Responses to NMED Comments on Part A and Part B Permit Renewal Application for the Triassic Park Waste Disposal Facility

Following are New Mexico Environment Department (NMED) comments dated February 5, 2013, and DBS&A responses regarding the Part A and B Permit Renewal Application for the Triassic Park Waste Disposal Facility, October 17, 2011, Revision 1 - April 30, 2012 (Renewal Application) dated April 30, 2012. These responses have been prepared based on guidance from the NMED at a meeting in Santa Fe on May 15, 2013, and on a conference call on June 18, 2013. Issues discussed in these responses have been incorporated into Revision 2 of the permit renewal documents, where applicable.

TRIASSIC PARK WASTE DISPOSAL FACILITY
 CHAVEZ COUNTY, NEW MEXICO
 FACILITY LAYOUT AND
 TOP OF LOWER DOCKUM
 STRUCTURAL CONTOUR ELEVATIONS

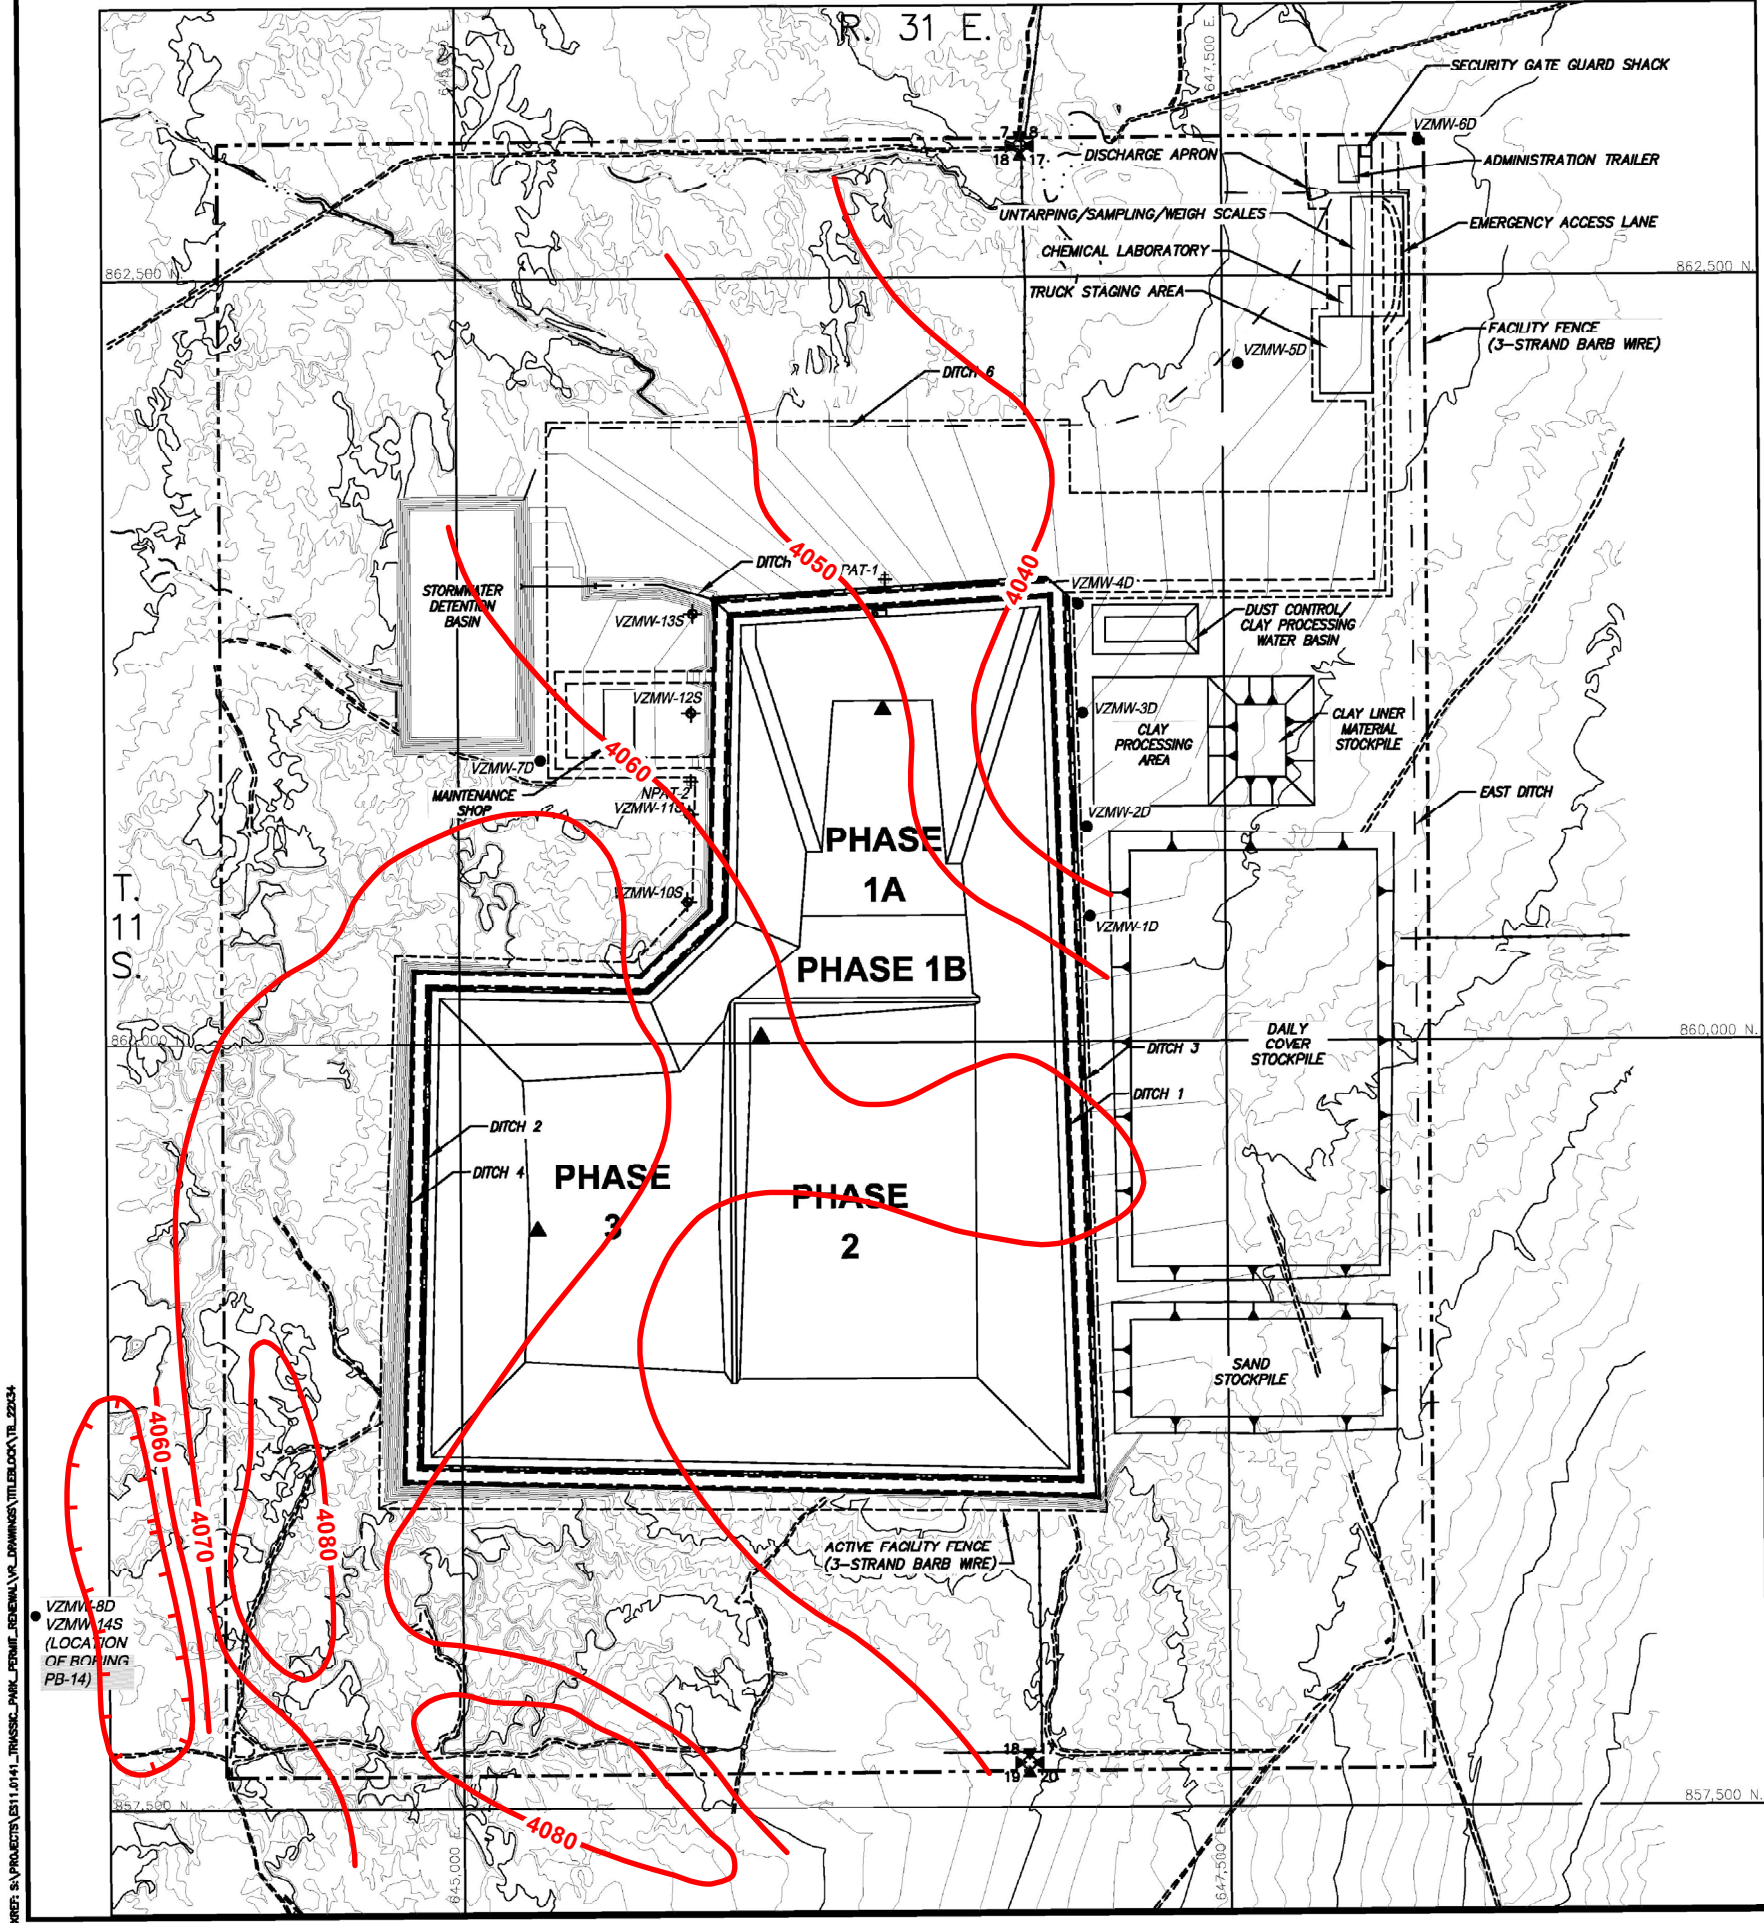
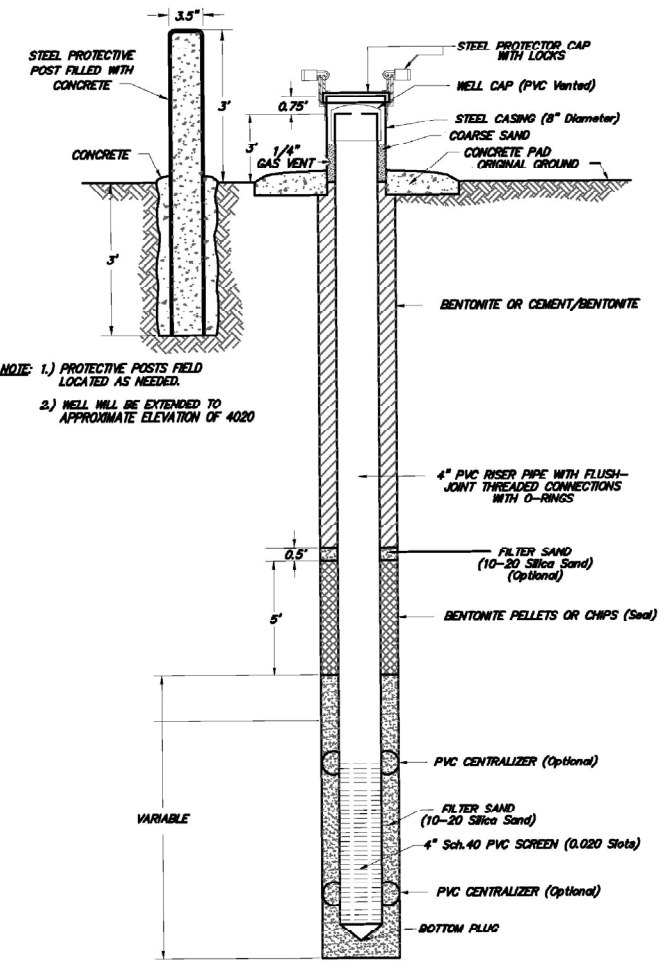
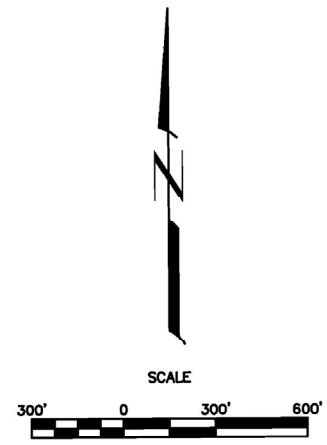
48. Attachment I, Vadose Zone Monitoring System Work Plan, Section 2.2.1, Well Locations, page I-8: Section 2.2.2.1, 2nd paragraph and Figure 2 specify the locations of deep monitoring wells. Section 2.2.1 states that the monitoring wells are intended to detect potential migration of fluids from the landfill. However, the deep monitoring wells VZMW-5D and VZMW-6D do not appear to be located downgradient of the Phase 1A cell. Based on the contour map of the top of Lower Dockum in Figure 3-6 of Attachment H and Figure 3-14 of Part B, leachate migrating from the Phase 1A cell along the Upper Dockum/Lower Dockum contact would likely flow south of boring PB-47 and not towards the northeast corner of the facility, where VZMW-6D is located. Review the likely pathways of leachate migration from the Phase 1A cell, and either provide justification for the current proposed locations of wells VZMW-5D and VZMW-6D or propose alternate locations.

50. Attachment I, Vadose Zone Monitoring System Work Plan, Section 2.2.2.2, Shallow Monitoring Wells, page I-12: Section 2.2.2.2 and Figure 2 specify locations of shallow monitoring wells that will be installed across the alluvium/Upper Dockum contact. Section 2.2.1 states that the monitoring wells are intended to detect the potential migration of fluids from the landfill. However, the Permittee did not submit sufficient information on the flow patterns of potential landfill leachate along the alluvium/Upper Dockum contact. Provide a structure contour map of the top of the Upper Dockum in order for NMED to assess the placement of the shallow monitoring wells.

The proposed deep monitoring well network is sufficient to detect any seepage from the Phase 1A cell that reaches and flows along the Upper Dockum/Lower Dockum contact. Any seepage from the Phase 1A cell that reaches the contact should flow predominantly to the east and be detected at proposed deep monitor wells VZMW-1D, VZMW-2D, VZMW-3D, and VZMW-4D. Figure 1 of this response to comments shows the structural contour elevations of the top of the Lower Dockum overlaid on the proposed facility layout. The top of the Lower Dockum beneath the Phase 1A cell dips primarily toward the east and northeast in the direction of wells VZMW-1D, VZMW-2D, VZMW-3D, and VZMW-4D. The proposed locations of wells VZMW-5D and VZMW-6D are unchanged; the proposed locations appear to be adequate to monitor for potential seepage downgradient of the facility because the Upper Dockum/Lower Dockum contact dips predominantly to the northeast.

Figure 2 of this response to comments shows the structural contour elevations of the top of the Upper Dockum overlaid on the proposed facility layout.

SHEET	1 of 1
DWG NO.	4

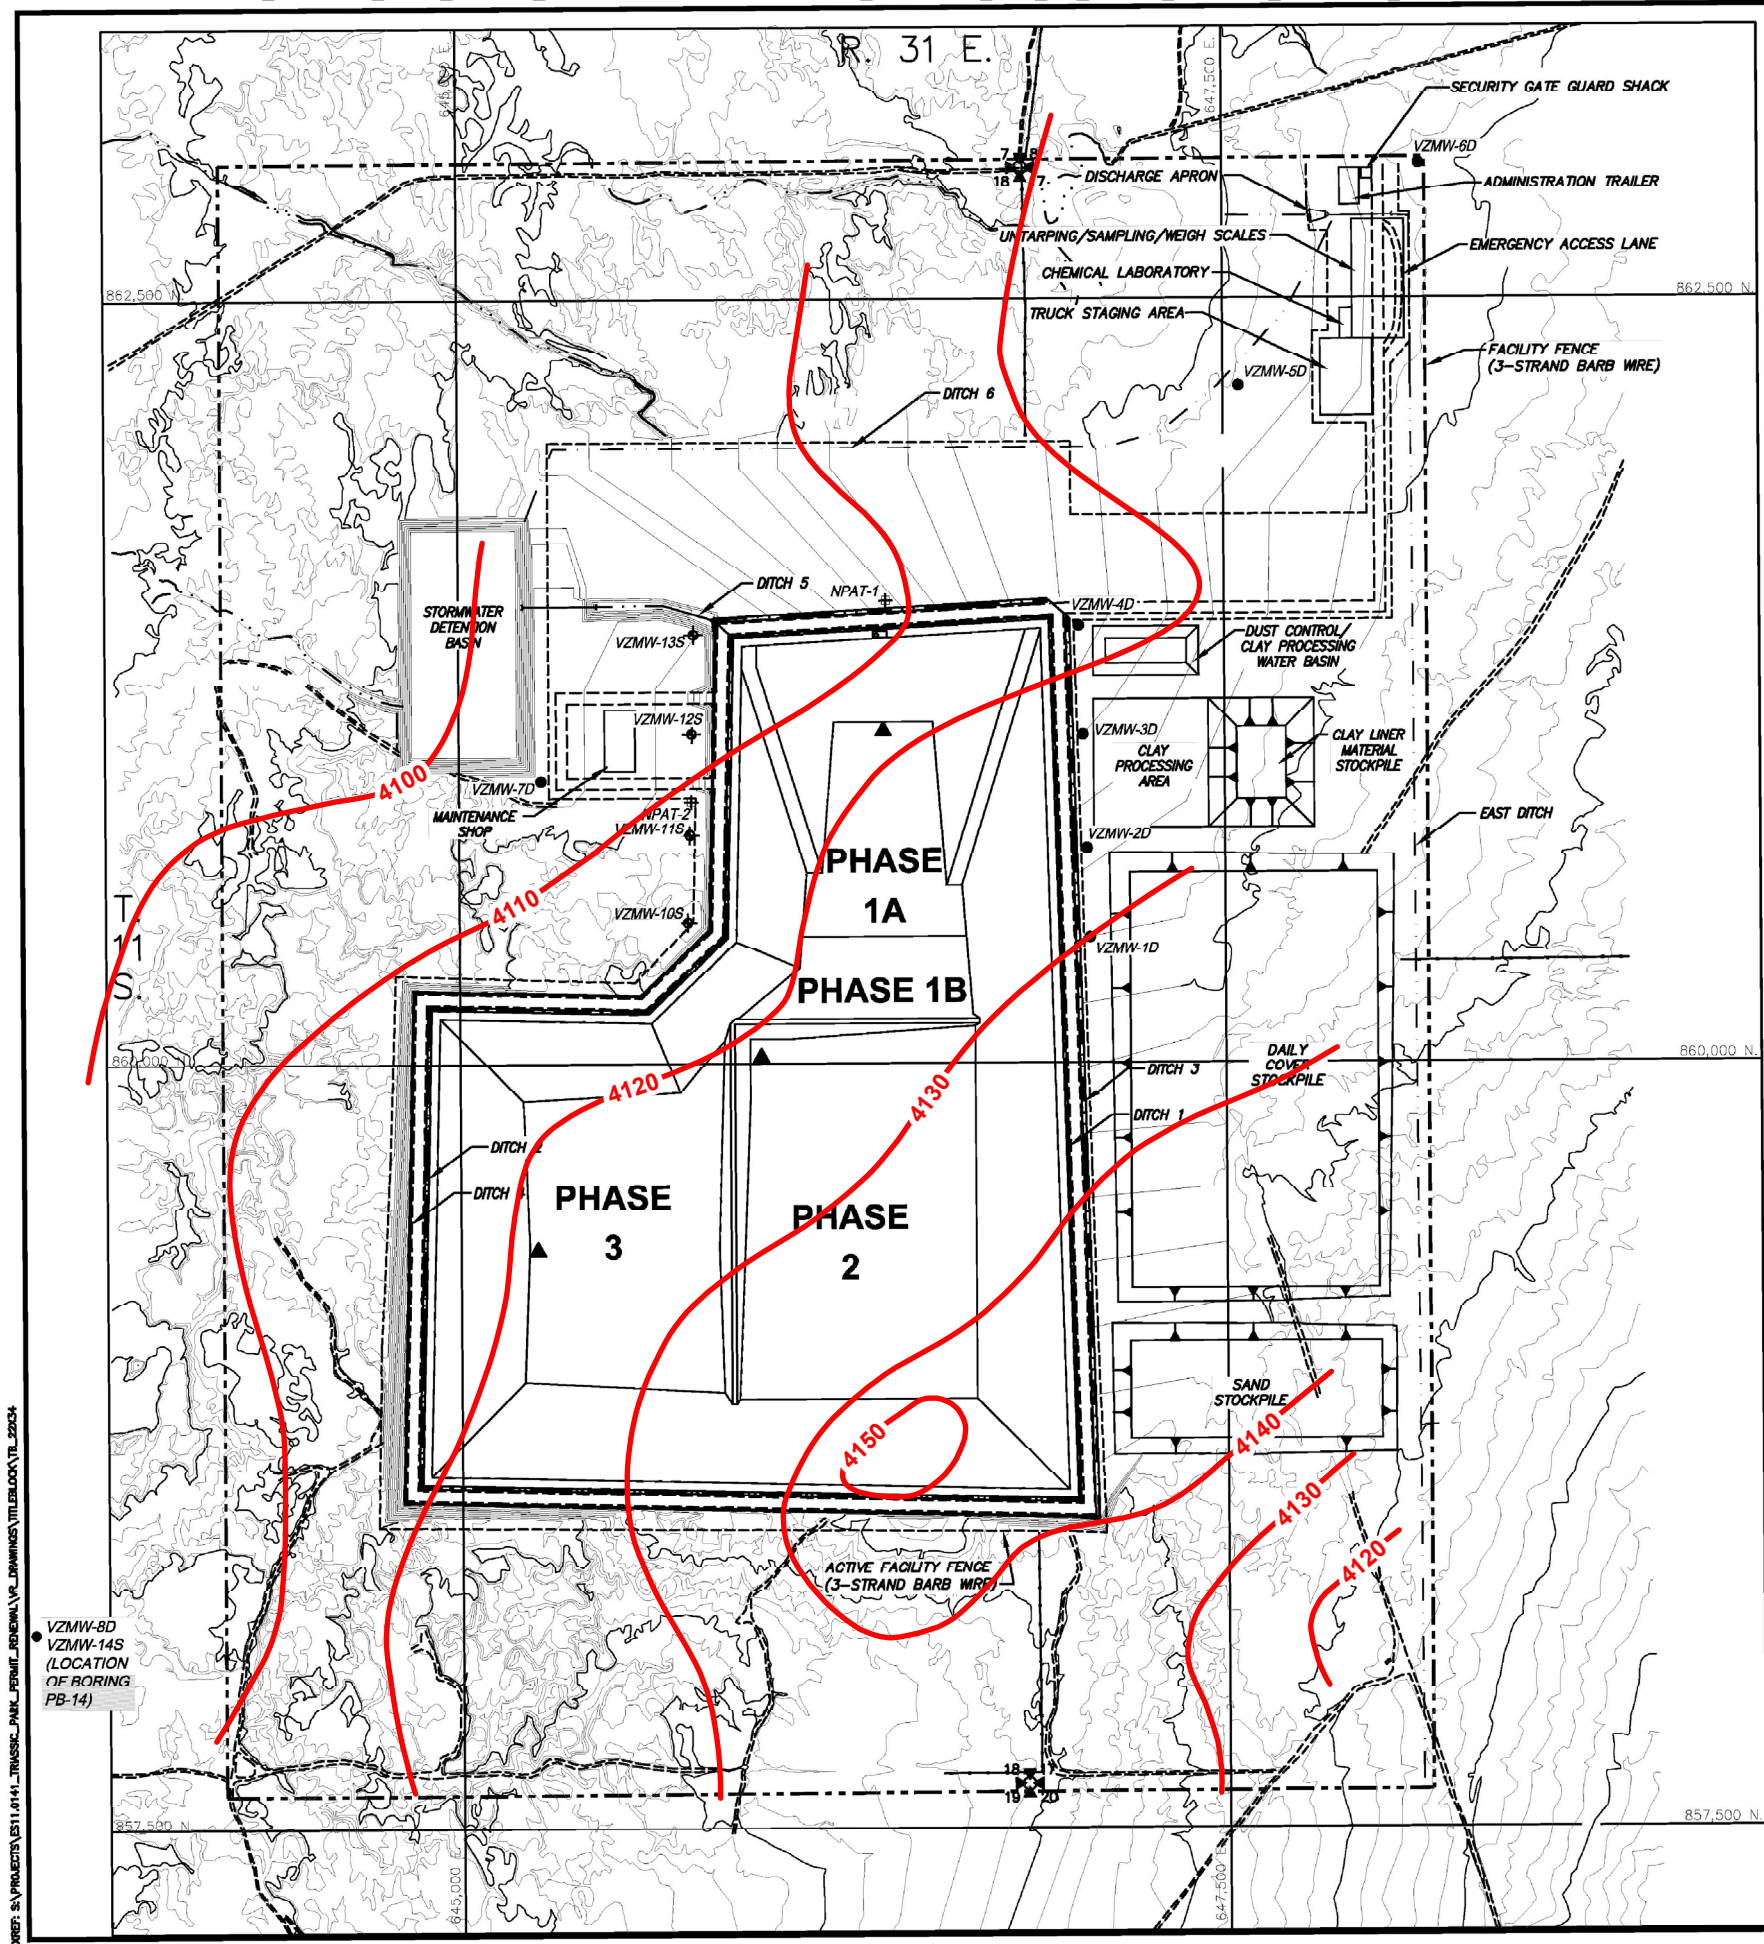
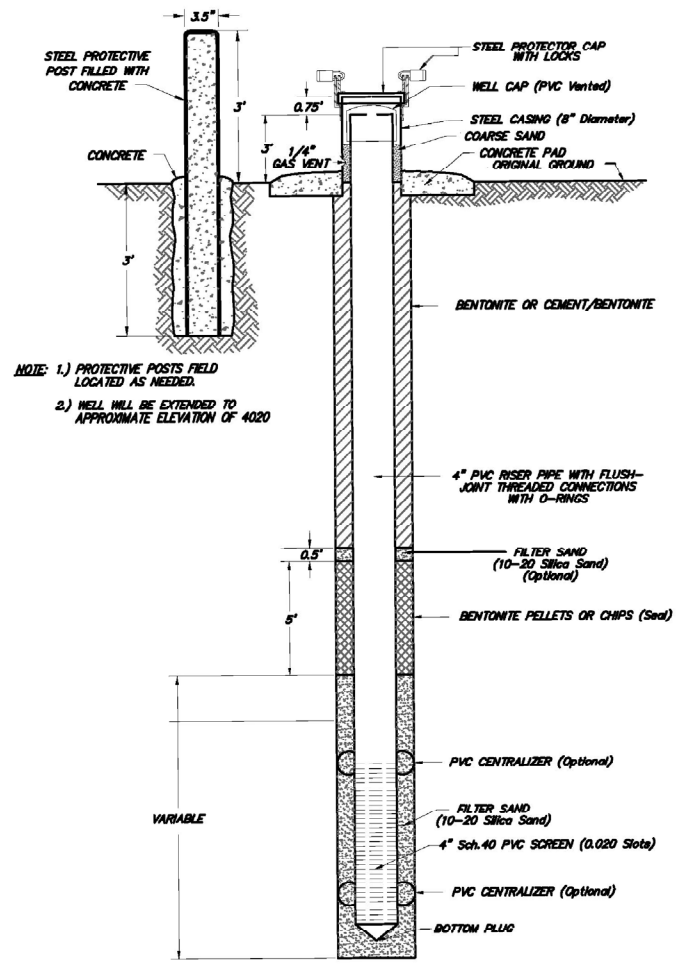
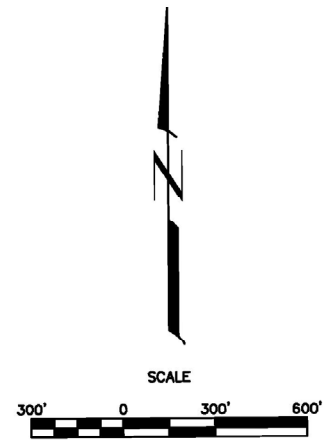
61. Attachment L1, Drawing 4 (revised), Facility Layout: The drawing provides "Typical Vadose Zone Monitoring Well Installation Detail", but the vertical distance between the top of the screen and the bottom of the bentonite seal is not defined. Also See comment# 58 on Attachment I (Vadose Zone Monitoring System Work Plan), elimination of Drawing 2 from Attachment I has left the completion depth of these monitoring wells ambiguous in the current design. Note that specifications for the neutron probe access well construction are not shown on the drawings, but are generally described in Section 2.2.2.3 of Attachment I. However, the target depth interval for completion of the neutron probe access wells is not provided. Provide the missing information.

Monitoring well installation details have been clarified on Drawing 4 to match text and figures in Attachment I, Vadose Zone Monitoring Plan. Figure 2a from Attachment I has been included as a second sheet for Drawing 4 to provide further clarification.
